SUBJECT: ISSUANCE OF AMENDMENT NO. 48 TO FACILITY OPERATING LICENSE NO. DPR-18 - R. E. GINNA NUCLEAR POWER PLANT (TAC NO. M79828)

AMENDMENT NO. 48 TO DPR-18 - R. E. GINNA NUCLEAR POWER PLANT DATED March 6, 1992

RELATED AMENDMENT NO. 48 TO FACILITY OPERATING LICENSE NO. DPR-18

R. E. GINNA NUCLEAR POWER PLANT

Figure 3.1-1: Ginna Reactor Vessel Heatup Limitations Applicable for the first 21 EFY using Reg Guide 1.99, Rev. 2

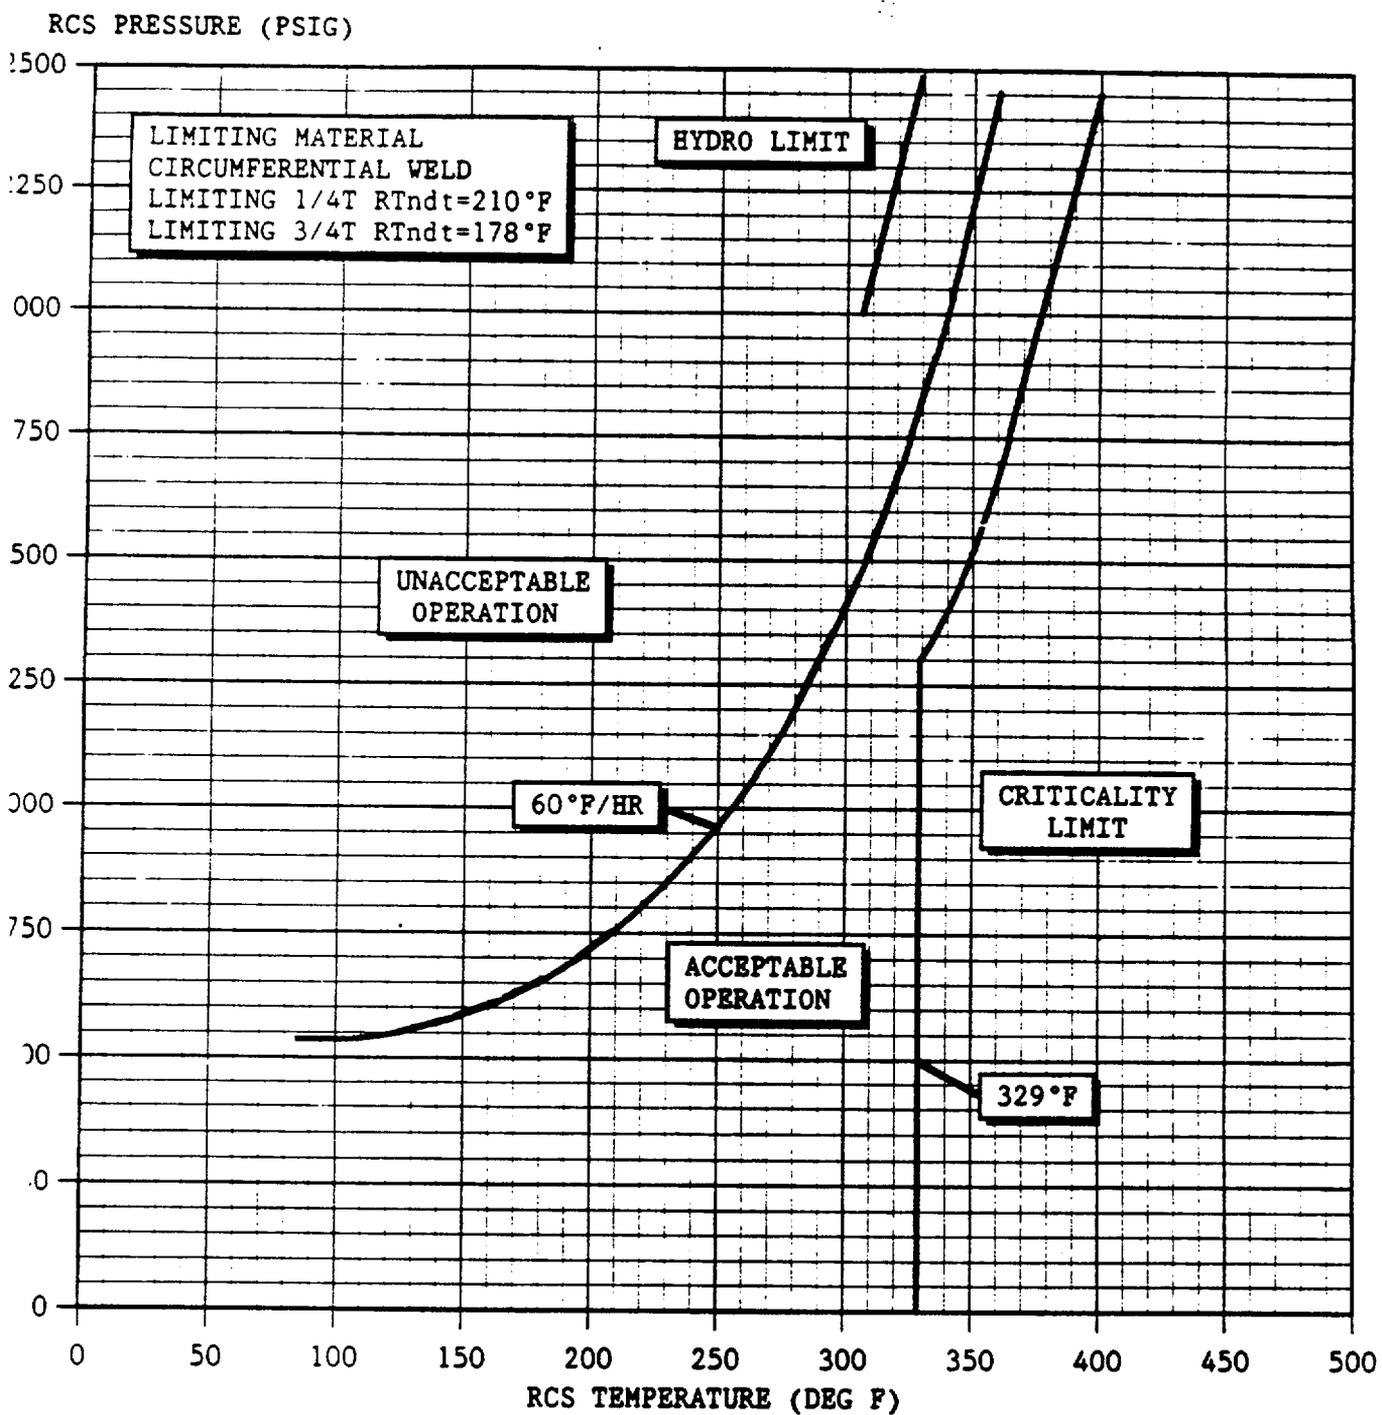
By letter, dated February 15, 1991 (Ref. 1), Rochester Gas and Electric Corporation, in response to GL 88-11, proposed amendments to the P/T curves in TS Figures 3.1-1 (for heatup) and 3.1-2 (for cooldown), changes in the LTOP system setpoint and restriction of the safety injection pump operability specified in TS 3.3.1 and 3.15.1. The licensee also provided the results of a safety analysis to support its proposed TS changes.

The licensee used the method in RG 1.99, Revision 2, to calculate an ART of 210°F at 21 EFPY at 1/4T for the same limiting weld metal. Substituting the ART of 210°F into equations in SRP 5.3.2, the staff verified that the proposed P/T limits for heatup, cooldown, and hydrotest meet the beltline material requirements in Appendix G of 10 CFR Part 50.

The reactor coolant temperature and pressure and system heatup and cooldown rates (with the exception of the pressurizer) shall be limited in accordance with Figures 3.1-1 and 3.1-2 for the first 21.0 effective full power years.

- a. Allowable combinations of pressure and temperature for specific temperature change rates are below and to the right of the limit lines shown. The heatup and cooldown rates shall not exceed 60°F/hr and 100°/hr, respectively. Limit lines for cooldown rates between those presented may be obtained by interpolation.
